Fifty-seventh session

test N.1 for readily combustible solids

Proposals to amend Figure 33.2.4.1:(A) cross-section of the 250 mm long mould in the Manual of Tests and Criteria

Transmitted by the expert from China*

A

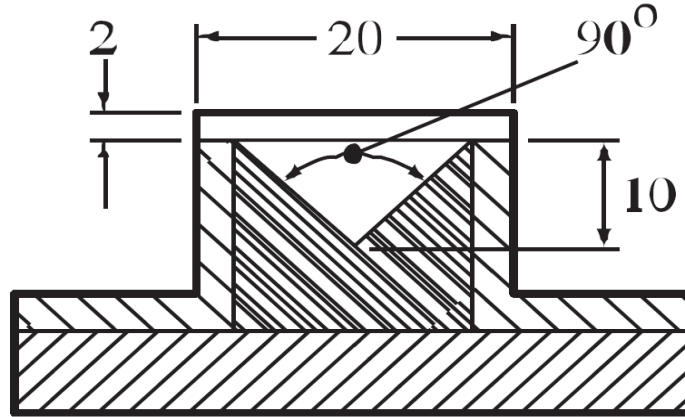
3. In section 33.2.4.2 - apparatus and materials, a mould 250 mm long with a triangular cross-section of inner height 10 mm and width 20 mm is used to form the train for the burning rate test. But in Figure 33.2.4.1:(A), the 20 mm width includes the thickness of the metal sheets on both sides as lateral limitation, therefore the width of triangle of the mould can only be less than 20 mm.
4. According to the description in section 33.2.4.2, Figure 33.2.4.1 shows the cross section of the mould without samples. In Figure 33.2.4.1:(A), there are two transverse lines on top which seem to indicate a lateral limitation in the transversal direction. But this lateral limitation in transversal direction covered some parts of lateral limitations in longitudinal direction.

5. Figure 33.2.4.1:(A) is not a real cross section of the mould. It includes both triangular cross-section and lateral limitation in the transversal direction may cause confusion to the experiment researcher. The purpose of using such a diagram seems to be consistent with the style of Figure 33.2.4.1 which using perspective to express more information.
